2010 STANDARD CONSTRUCTION DETAILS REVISION

DelDOT – Quality Section

SECTION I – BARRIER

DETAIL C-3, SHEET 1 OF 1 ENTRANCES

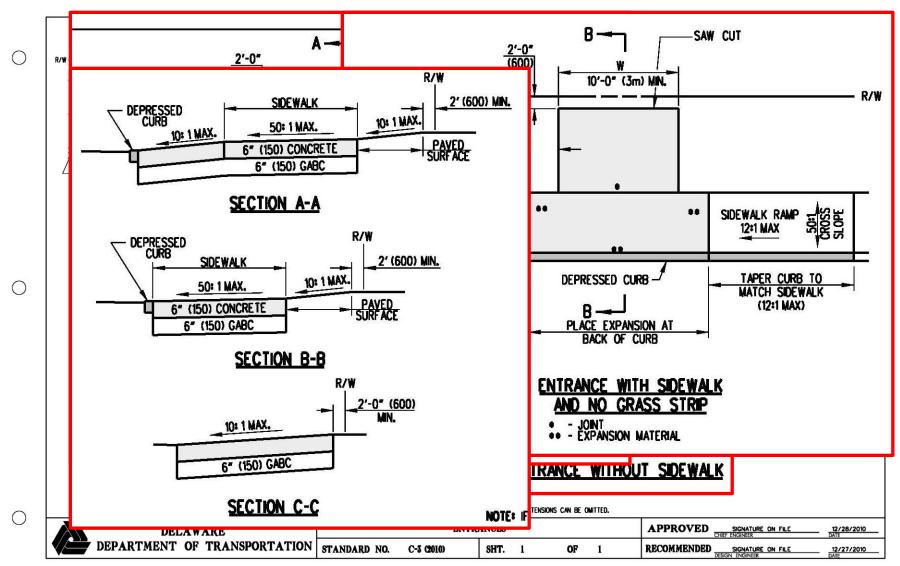
- DETAIL C-3, SHEET 1 OF 1 ENTRANCES
 - ADDED A DETAIL FOR ENTRANCES WITH SIDEWALK AND NO GRASS STRIP
 - MINOR CHANGE TO DETAIL FOR ENTRANCES WITH SIDEWALK AND GRASS STRIP
- DETAIL C-4, SHEET 1 OF 1 CURB OPENING DETAILS
 - CONSOLIDATED PREVIOUS YEARS 4 SHEETS INTO 1 SHEET AND HAD STORMWATER APPROVE 2 DESIGNS TO BE USED REGARDLESS OF THE TYPE OF CURB.

DETAIL D-5, SHEET 1 OF 9 DRAINAGE INLET ASSEMBLY

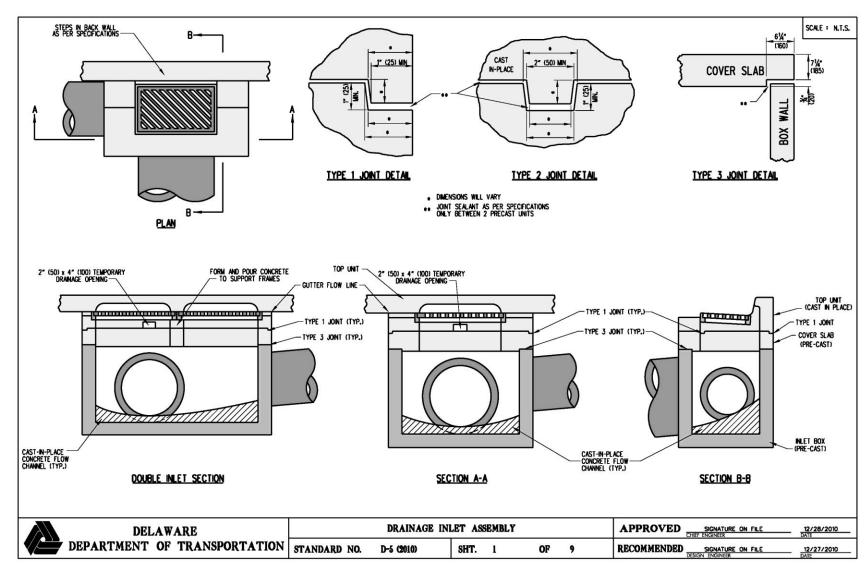
- RENUMBERED THE D-5 DETAILS OF THE DRAINAGE SECTION WITH THE ADDITION OF THE 9TH SHEET.
- DETAIL D-5, SHEET 1 OF 9 DRAINAGE INLET ASSEMBLY
 - NOW SHOWING THE CURB IN THE TOP UNIT TO EXTEND PAST THE EDGES OF THE BOX.

DETAIL D-5, SHEET 3 OF 9 DRAINAGE INLET TOP UNITS

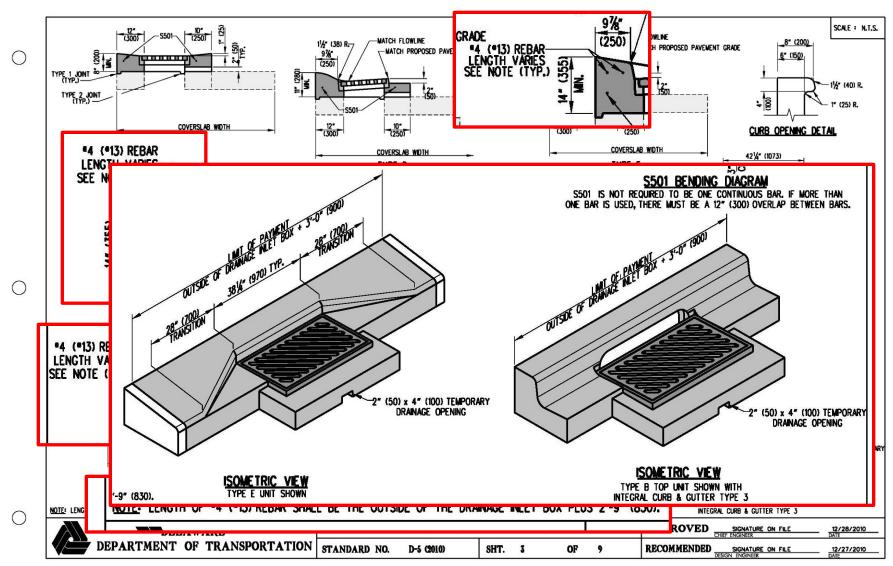
- DETAIL D-5, SHEET 3 OF 9 DRAINAGE INLET TOP UNITS
 - ADDED A LIMIT OF PAYMENT DIMENSION TO THE ISOMETRIC VIEWS.
 - ADDED A NOTE TO CLARIFY THE LENGTH OF THE REBAR IN THE TYPE B, C,
 AND E TOP UNITS.

DETAIL D-5, SHEET 6 OF 9

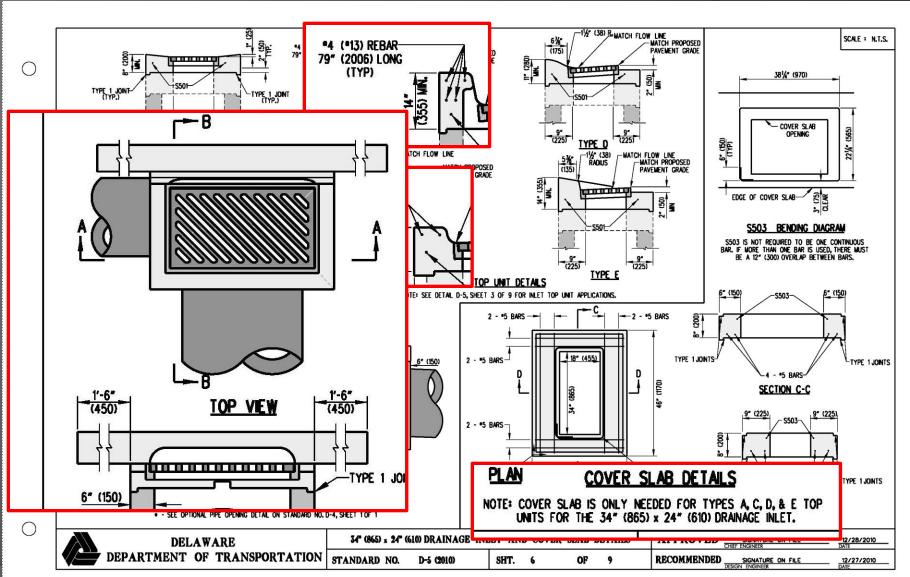
- DETAIL D-5, SHEET 6 OF 9 34" X 24" DRAINAGE INLET AND COVER SLAB DETAILS
 - CHANGED THE NOTE IN THE COVER SLAB DETAIL SECTION TO SHOW THE NEED FOR A COVER SLAB ON A TYPE C TOP UNIT.

- CHANGED THE LENGTH OF THE REBAR IN TYPE B AND C TOP UNITS.
 - NOW SHOWING THE CURB IN THE TOP UNIT TO EXTEND PAST THE EDGES OF THE BOX.
- •DETAIL D-5, SHEET 7 OF 9 34" X 18" DRAINAGE INLET DETAILS

DETAIL D-5, SHEET 7 OF 9 34" (865) X 18" (455) DRAINAGE INLET DETAILS

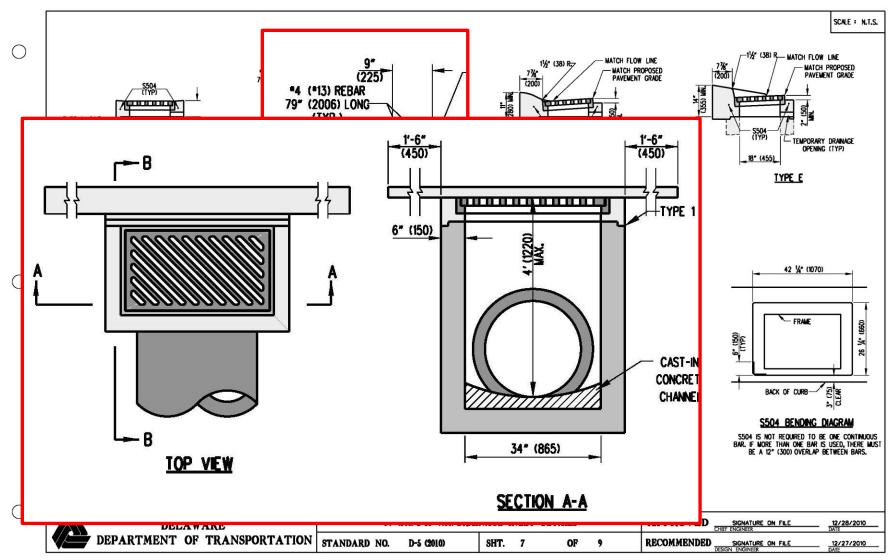
- CHANGED THE LENGTH OF THE REBAR IN THE TYPE B AND C TOP UNITS.
 - NOW SHOWING THE CURB IN THE TOP UNIT TO EXTEND PAST THE EDGES OF THE BOX.

DETAIL D-5, SHEET 9 OF 9 DOGHOUSE INLET BOX

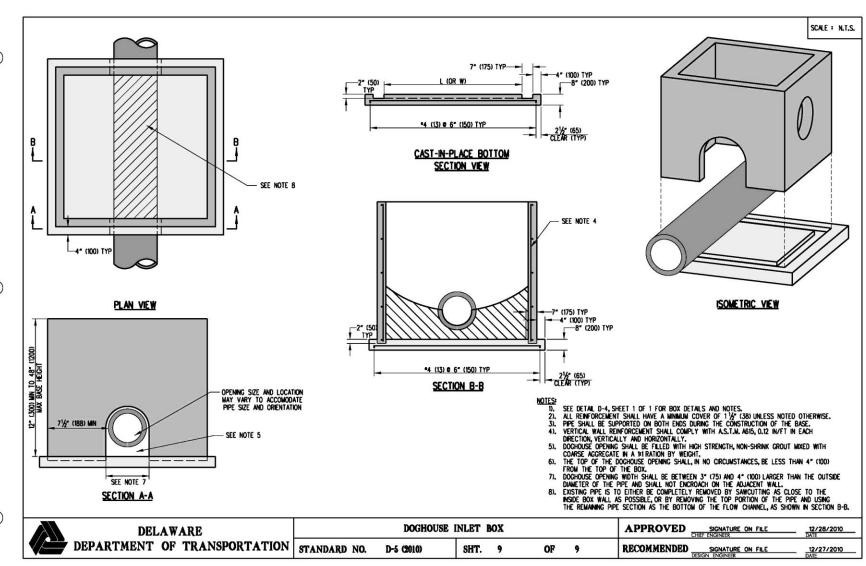
- DETAIL D-5, SHEET 9 OF 9 DOGHOUSE INLET BOX
 - THIS IS A BRAND NEW DETAIL.
- DETAIL D-8, SHEET 1 OF 1 PIPE BEDDING
 - CHANGED THE PIPE TRENCH WIDTH TO 18" ON EACH SIDE OF THE PIPE.
 - CLARIFIED AND SIMPLIFIED THE DIMENSIONING ON THE BEDDING FOR CLASS A BEDDING.
 - CLARIFIED AND SIMPLIFIED THE DIMENSION ON THE EARTH CUSHION ON THE CLASS C BEDDING.
